**SUBDIVISION REVIEW SHEET****CASE NO.:** C8-2017-0170.0A**P. C. DATE:** September 25, 2018**SUBDIVISION NAME:** Second Resubdivision of a Portion of Lot 8, Block A, Eastover**AREA:** 0.25 acres**LOT(S):** 2**OWNER/APPLICANT:** MX3 Homes, LLC  
(Sal Martinez)**AGENT:** Southwest Engineers  
(Travis Flake)**ADDRESS OF SUBDIVISION:** 3611 Munson Street**GRIDS:** L-22**COUNTY:** Travis**WATERSHED:** Boggy Creek**JURISDICTION:** Full Purpose**EXISTING ZONING:** SF-3-NP**DISTRICT:** 1**PROPOSED LAND USE:** Residential**NEIGHBORHOOD PLAN:** MLK**SIDEWALKS:** Sidewalks will be provided along Munson Street.**VARIANCE:** From Land Development Code (LDC) 25-4-175 to allow a flag lot.

## MEMORANDUM

**SUBJECT:** C8-2017-0110.0A Second Resubdivision of a Portion of Lot 8, Block A, Eastover subdivision Flag Lot variance request

RE: Eastover; Second Resubdivision of a Portion of Lot 8 Block A  
SWE Project No. 0556-036-16  
Variance to LDC Section 25-4-175(A)(2)

- (1) Driveway and Utility Exhibit
- (2) Surrounding Area Map

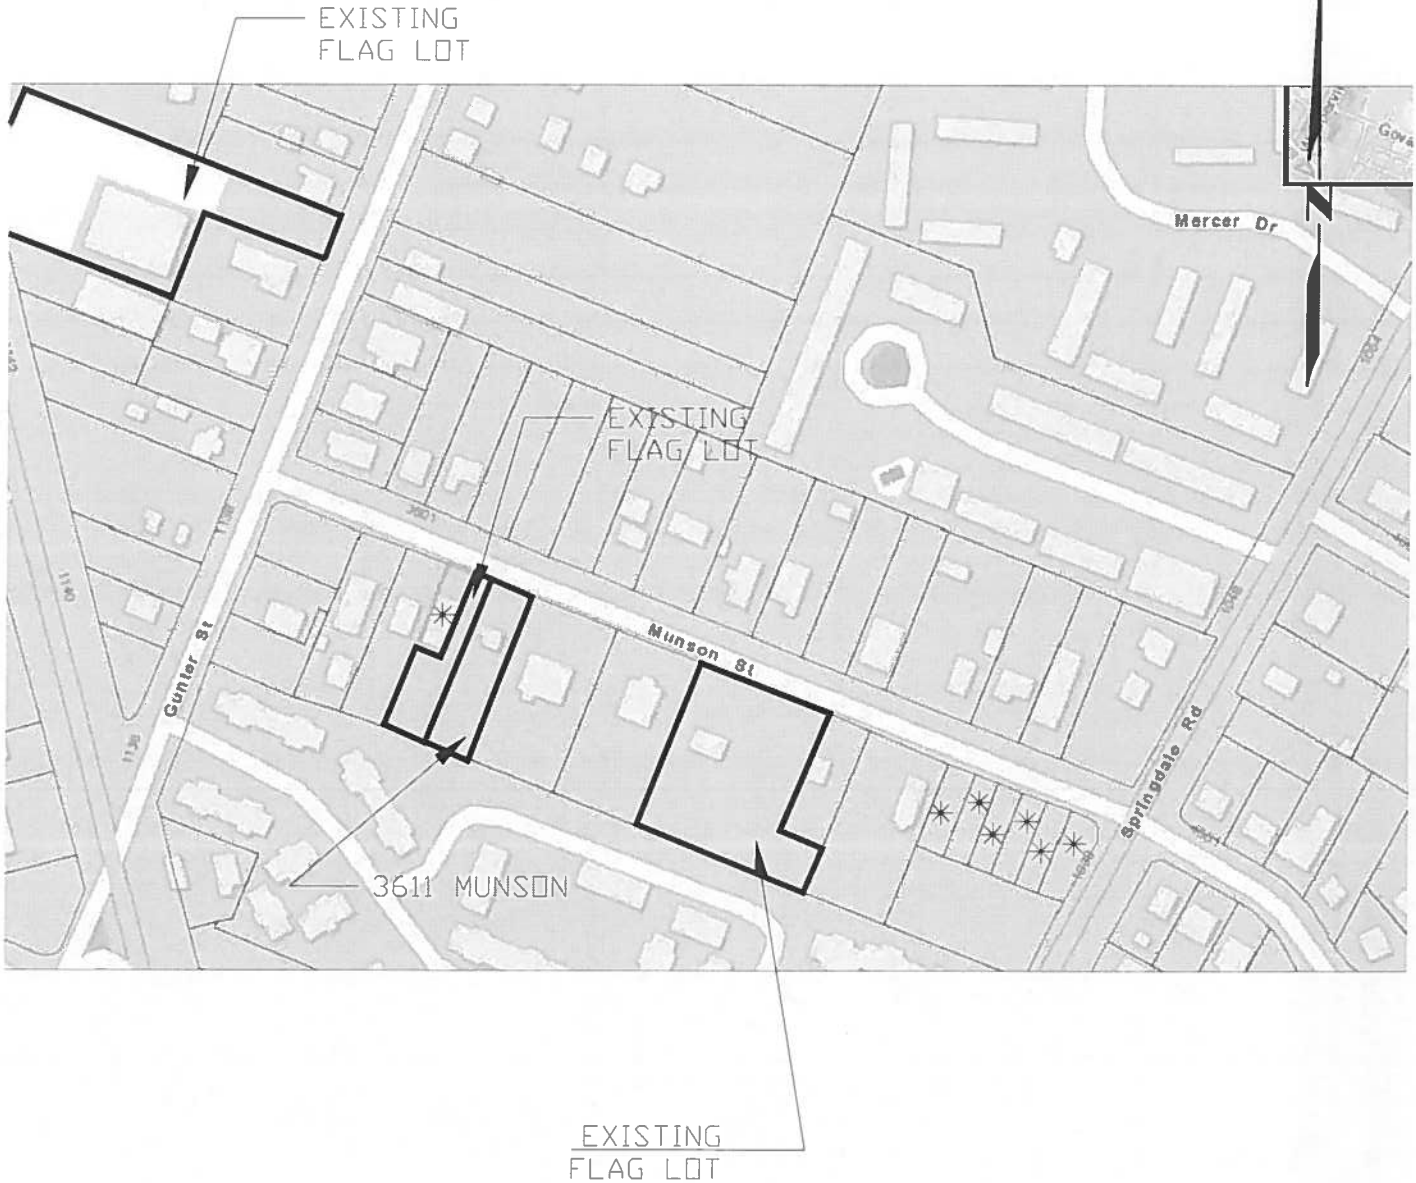
- (a)
- (i) The site provides accessibility for emergency responders via Munson Street and an increase in emergency vehicle access distance approved for Lot 8D per exception 3 to section 503.1 of the City of Austin fire code in effect on September 16, 2013.
  - (ii) The site has adequate room for required utilities as demonstrated on the attached Driveway and Utility Exhibit.
  - (iii) The site enhances environmental and tree protection by minimizing the impacts to existing trees, including not removing protected trees.
  - (iv) The site is compatible with the surrounding neighborhood as demonstrated on the attached Surrounding Area Map.

*The applicant has provided a driveway and utility plan to reviewers for the City of Austin Water and Wastewater review and Austin Energy Departments. The reviewers have determined after review of the utility/driveway plan that there is adequate room to provide utility service to both lots and utilities will not cross the proposed new lot lines.*

## SURROUNDING AREA

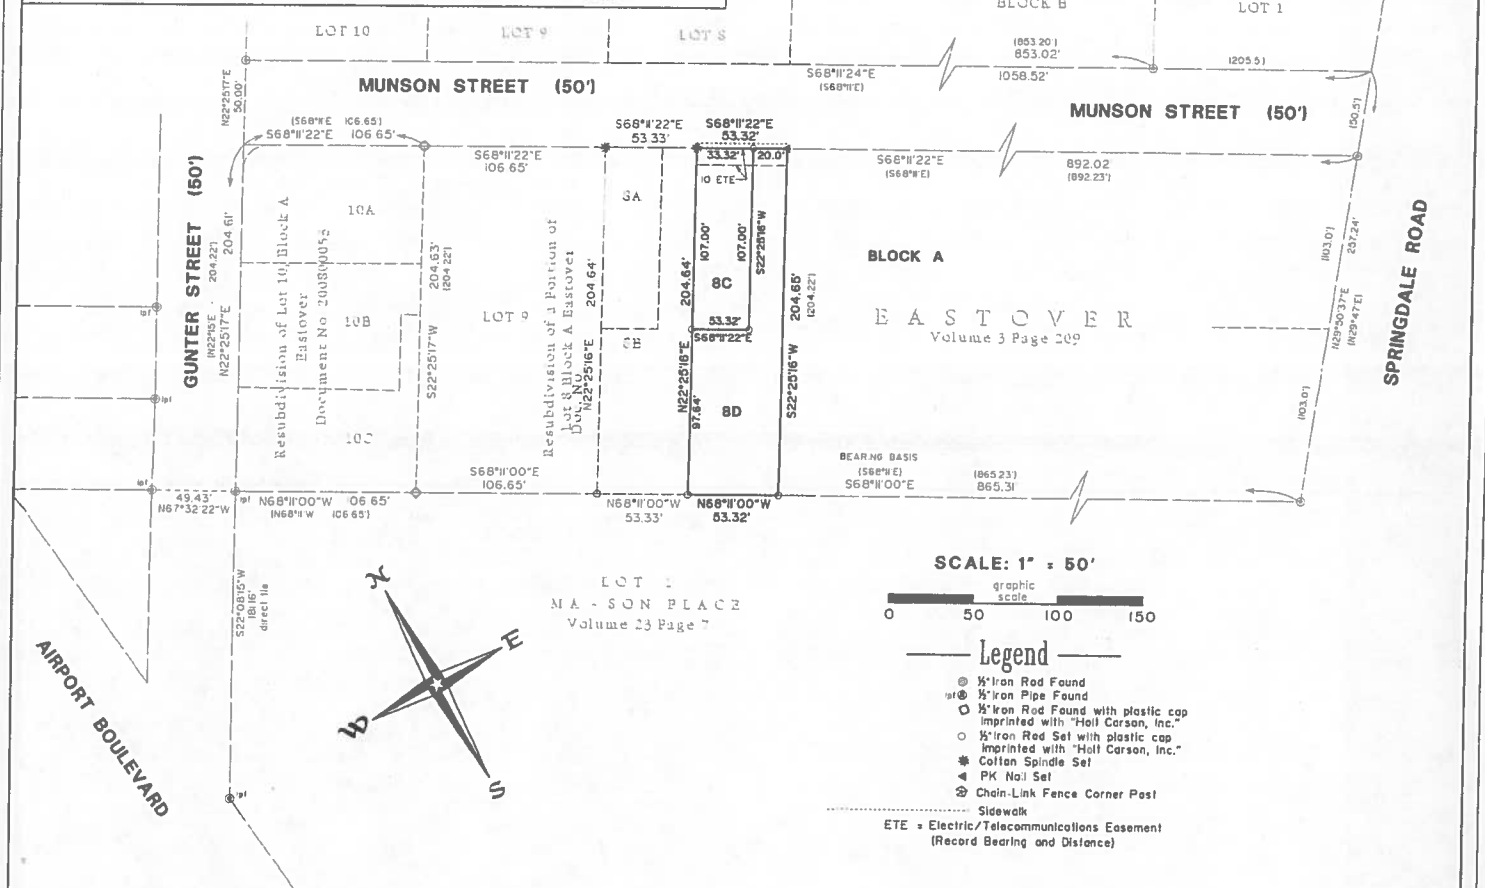
*The immediate area is zoned SF-3-NP which is the appropriate zoning for the proposed use. See attached, Surrounding Neighborhood Exhibit which generally shows the development pattern in the immediate vicinity.*
